Subject: Pedestrian Safety in Wilson Borough

Pedestrian Safety Assessment

For: Wilson Borough, Northampton Street Corridor between 15th and 25th Streets

Northampton Street @ Meuser Park

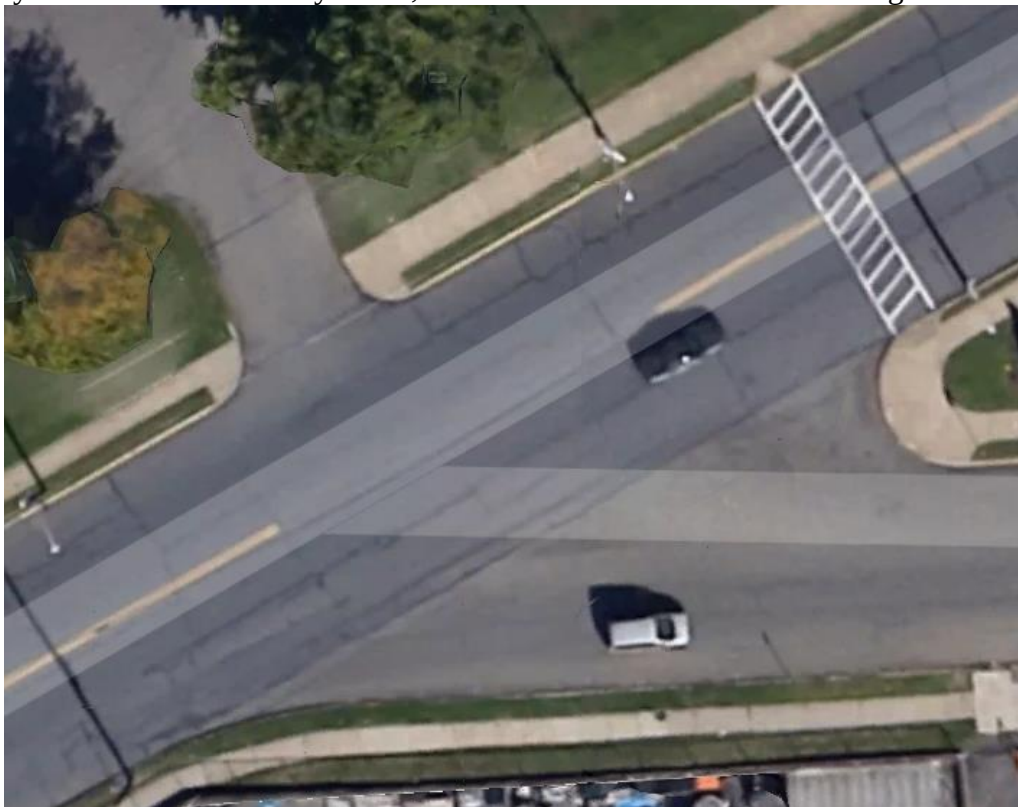
Two ladder-style crosswalks in similar condition. Paint approximately 60% worn. Should be repainted. Pedestrian has right of way to cross the street, though there is no signalization. If you were standing on the curb to cross, do you think traffic would yield (as is their duty)?

Northampton Street @ Wood Avenue
No sidewalks or crosswalks on either side.

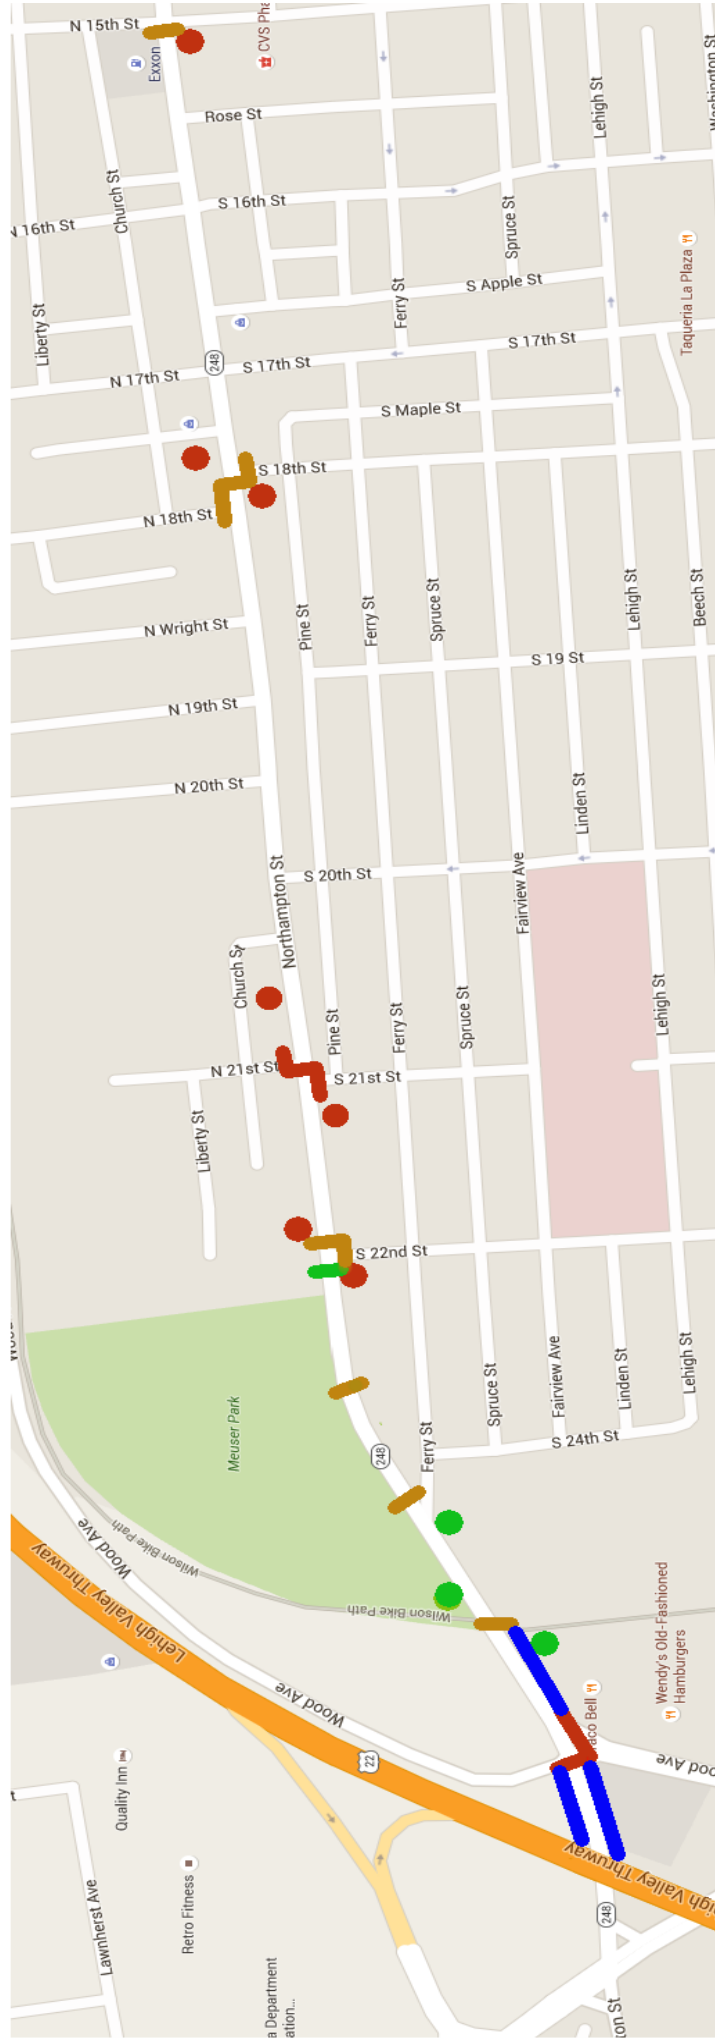
Sidewalk extends from 25th Street through Route 22 underpass then ends midblock without warning (along both sides of Northampton Street). Recommend extending sidewalk on southern side to Wilson Bike Path, and on northern side to Wood Avenue then installing marked crosswalk to traverse Northampton Street to meet southern sidewalk.
